Application for Licence Amendment

Licence Number	L9036/2017/1
Licence Holder	Pilgangoora Operations Pty Ltd
ACN	616 560 395
File Number	DWERVT15824~1
Premises	<p>Pilgangoora Lithium Project</p> <p>Mining tenements M45/1230 and M45/1231</p> <p>MARBLE BAR WA 6760</p> <p>As defined by the Premises map attached to the Revised Licence</p>
Date of Report	27/05/2025
Decision	Revised licence granted

Figure 2: Turkey's nest location

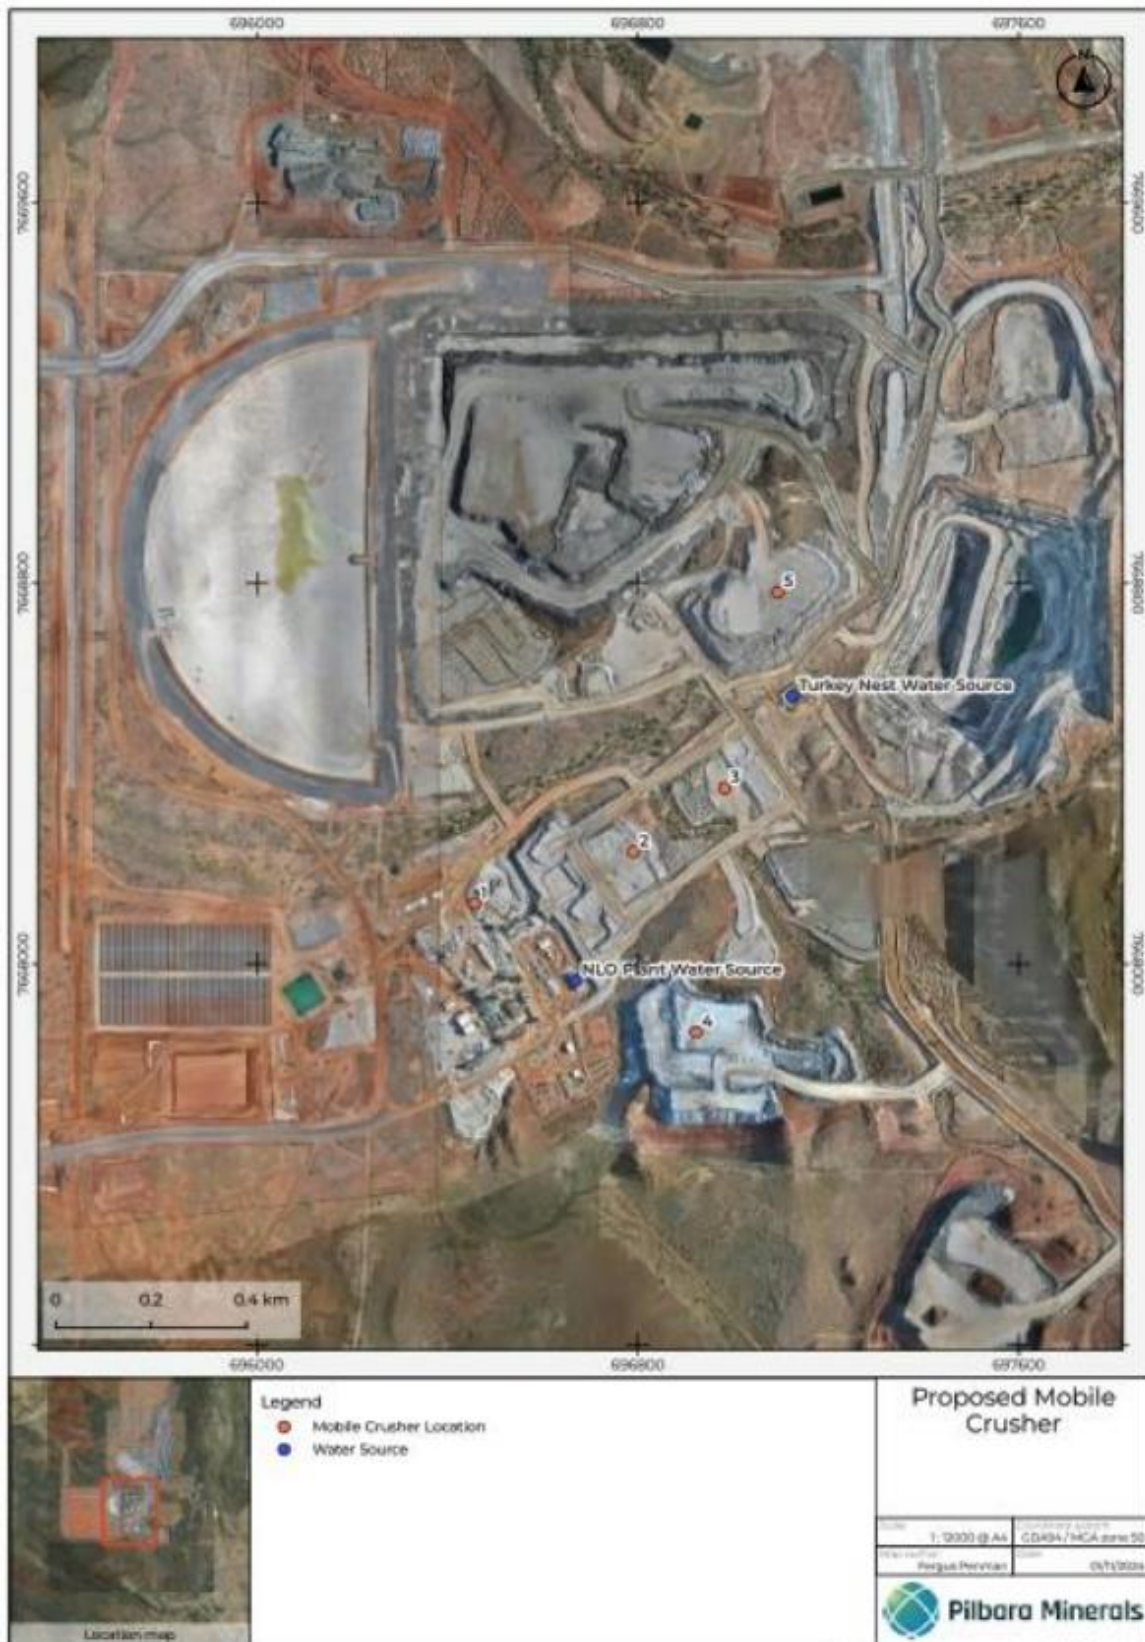
The Licence Holder has proposed that if nitrate levels are elevated beyond the following trigger values, then the water from the south pit will be redirected to the turkey's nest (Figure 2) for use as dust suppression, rather than discharged into Pilgangoora Creek:

- water sampled from the south pit:
 - 400 mg/L, in accordance with the livestock drinking water quality value for cattle (ANZECC 2000).

- water sampled from downstream Pilgangoora Creek:
 - 25 mg/L, corresponding closely to the 90% environmental protection level derived from a Pilbara-based study (A van Dam, Bankin, and Parry 2022); or
 - result is within 10% of a sampling result taken from upstream Pilgangoora Creek.

Figure 3: Proposed dewatering pipeline and discharge point locations

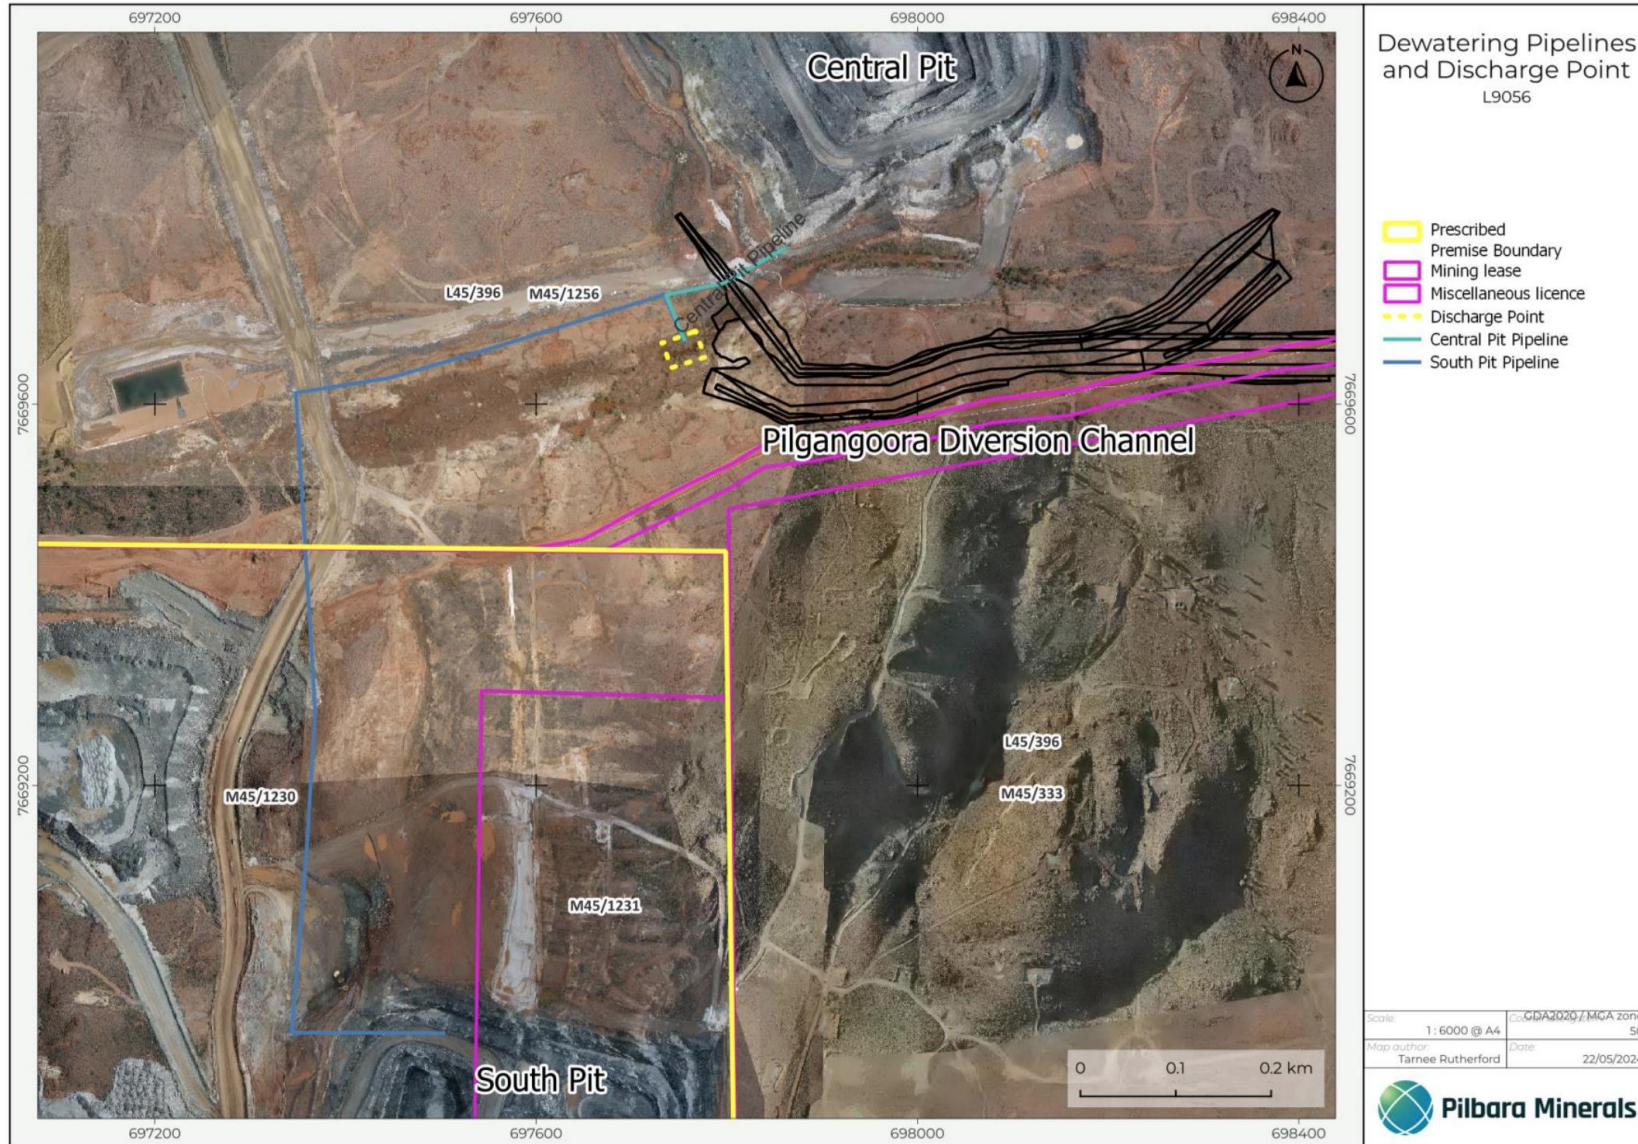
A 1.5 km dewatering pipeline will extend north from the south pit in mining tenement M45/1230 to within the L9056/2017/1 prescribed premises boundary, also held by the Licence Holder, where it will connect with an existing pipeline and the discharge point. The location of the dewatering pipeline and the discharge point is shown in Figure 3, Appendix 2. The dewatering pipeline will be secured with stakes. There are no records of threatened or priority flora or fauna near the pipeline route, and the department notes that it follows an existing road that crosses over Pilgangoora Creek, approximately 0.4 km west of the approved discharge point. Water to be discharged will be fresh to brackish.

As the dewatering pipeline crosses over Pilgangoora Creek, the department notes that a permit to interfere with bed and banks under the *Rights in Water and Irrigation Act 1914* may be required and the Licence Holder should engage with the department's water licensing branch to determine whether a permit to interfere with bed and banks is required for the proposed pipeline.
